Date	Revisions
10/19/18	2. PER TOWNSHIP COMMENTS
10/03/18	1. PER TOWNSHIP COMMENTS

Revised Final Subdivision and Land Development Plan
SPRINGBROOK ANNEX AT GOOD DRIVE
 Layout and Subdivision Plan
 East Hempfield Township, Lancaster County, PA

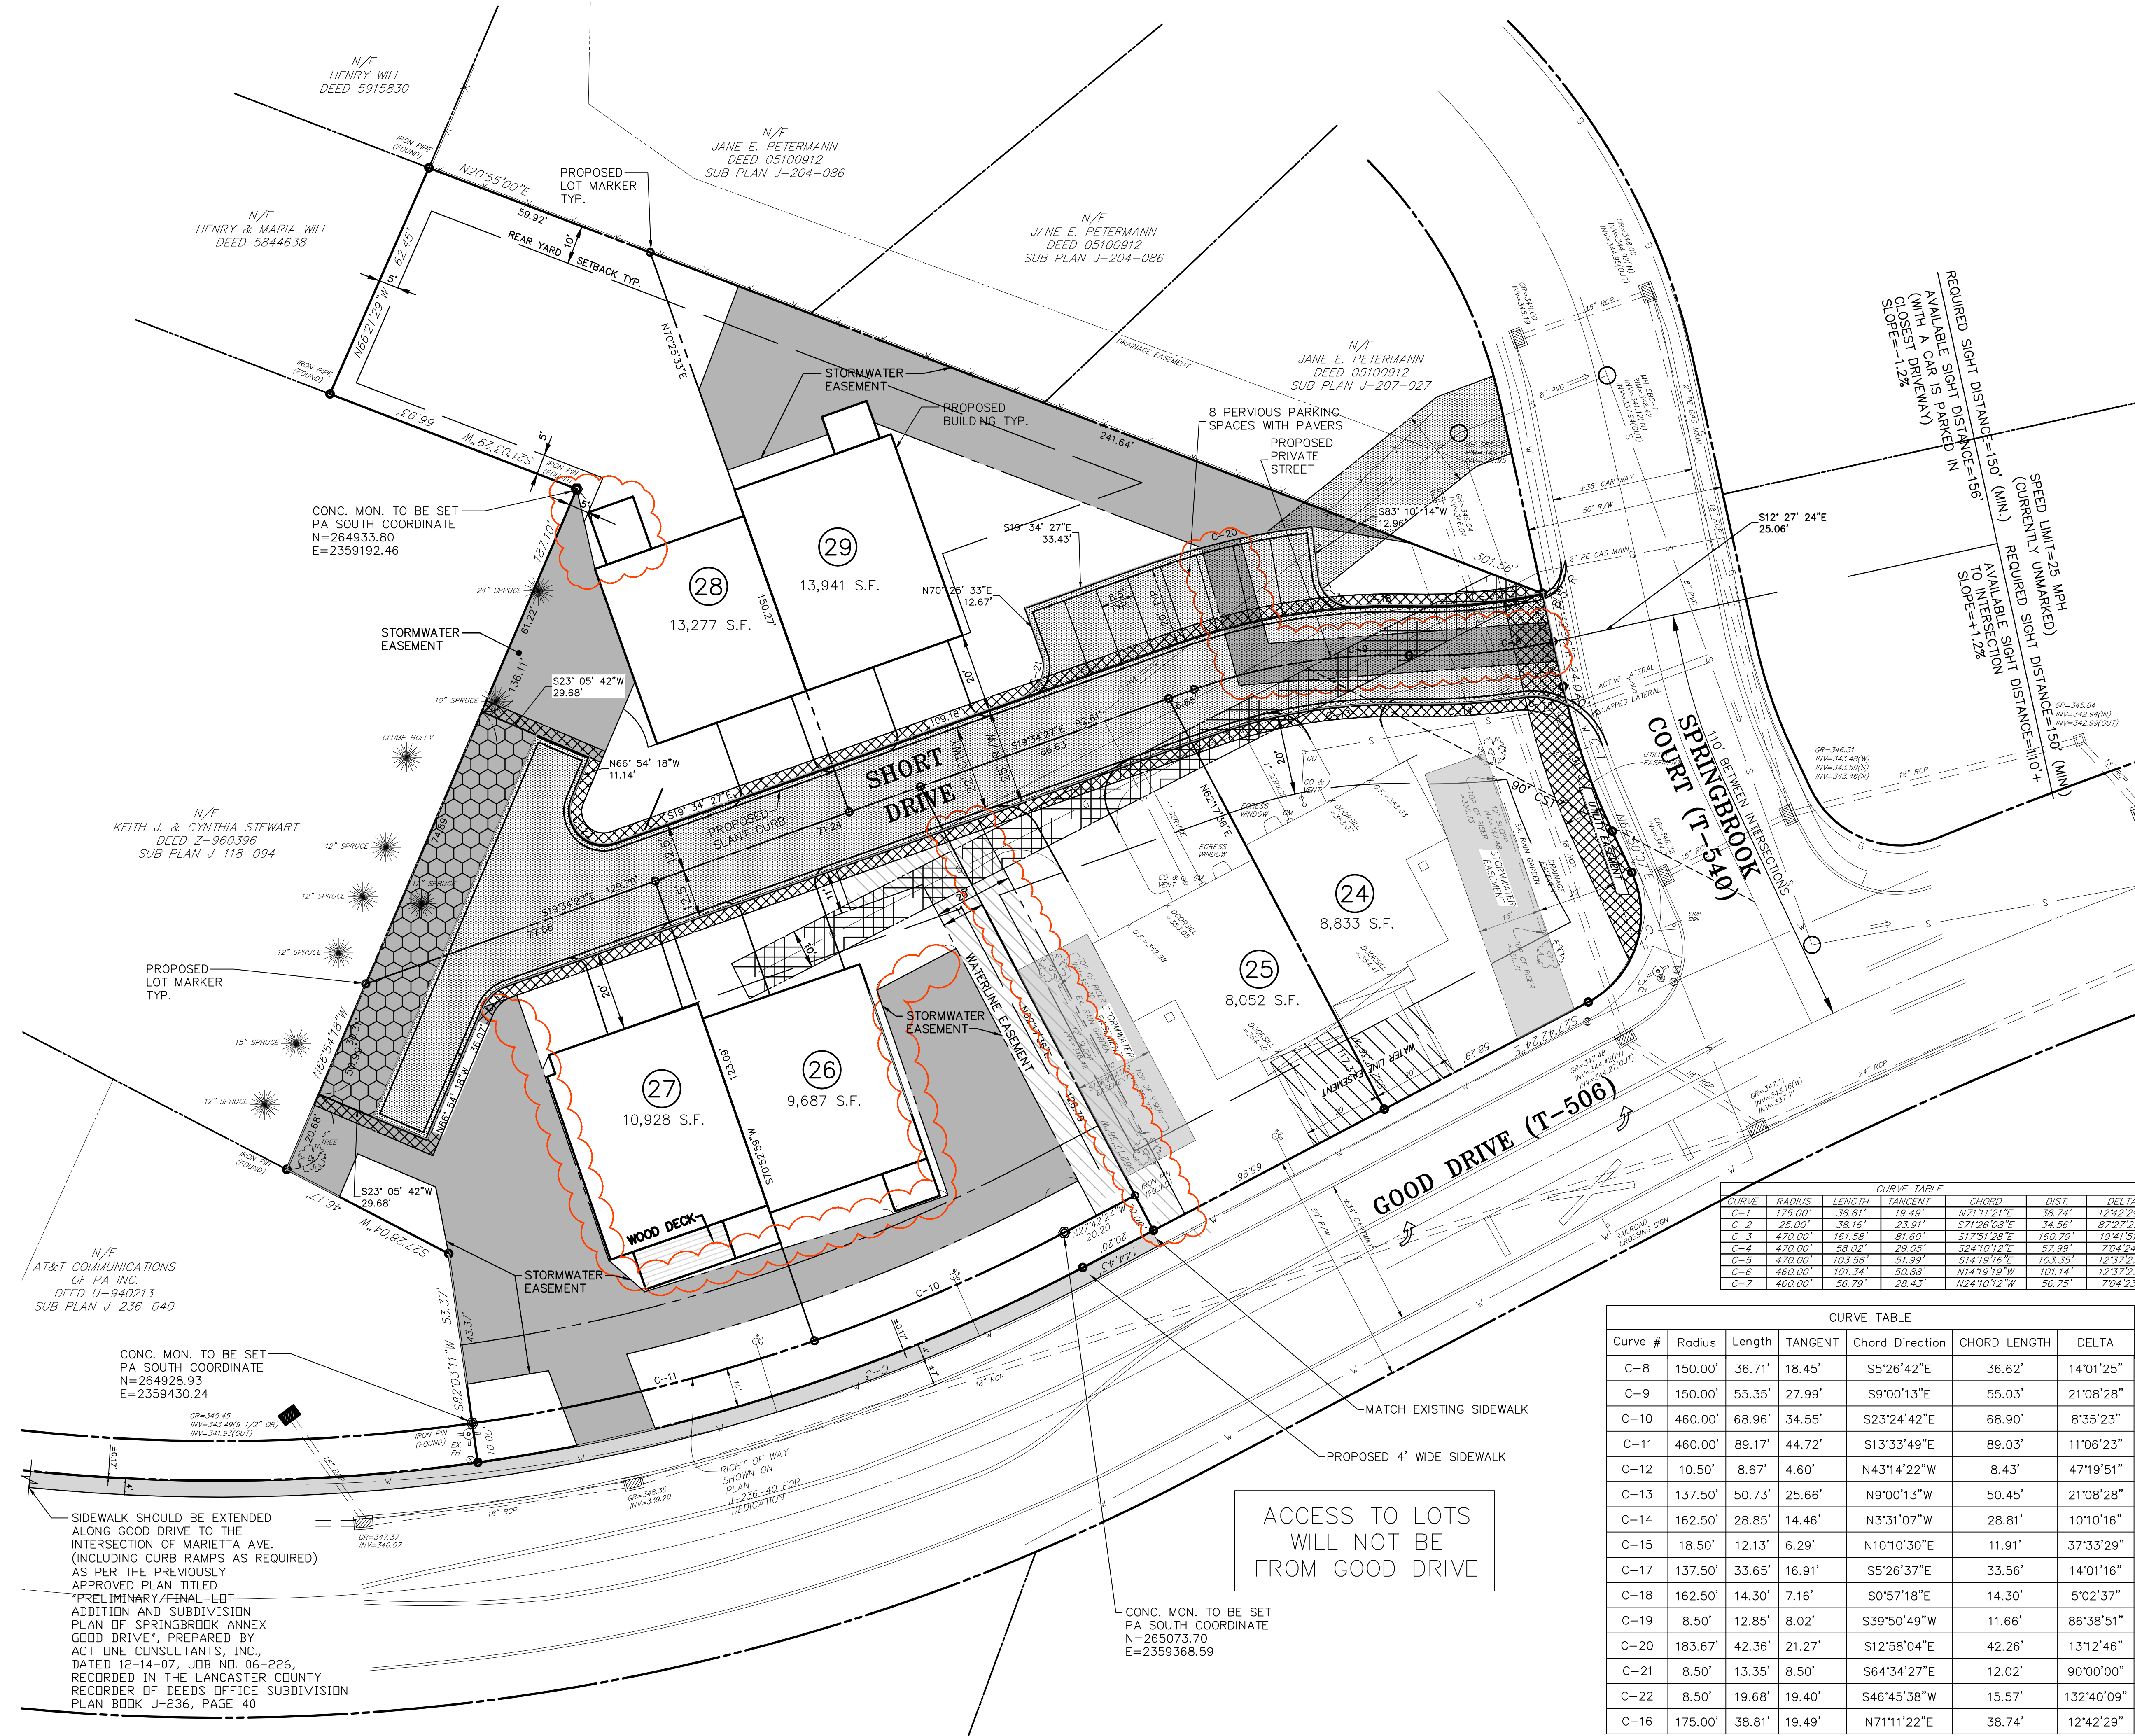
SIDEWALK SHOULD BE EXTENDED ALONG GOOD DRIVE TO THE INTERSECTION OF MARIETTA AVE. (INCLUDING CURB RAMPS AS REQUIRED) AS PER THE PREVIOUSLY APPROVED PLAN TITLED "PRELIMINARY/FINAL-LBT ADDITION AND SUBDIVISION PLAN OF SPRINGBROOK ANNEX GOOD DRIVE", PREPARED BY ACT ONE CONSULTANTS, INC., DATED 12-14-07, JOB NO. 06-226, RECORDED IN THE LANCASTER COUNTY RECORDER OF DEEDS OFFICE SUBDIVISION PLAN BOOK J-236, PAGE 40

ACCESS TO LOTS WILL NOT BE FROM GOOD DRIVE
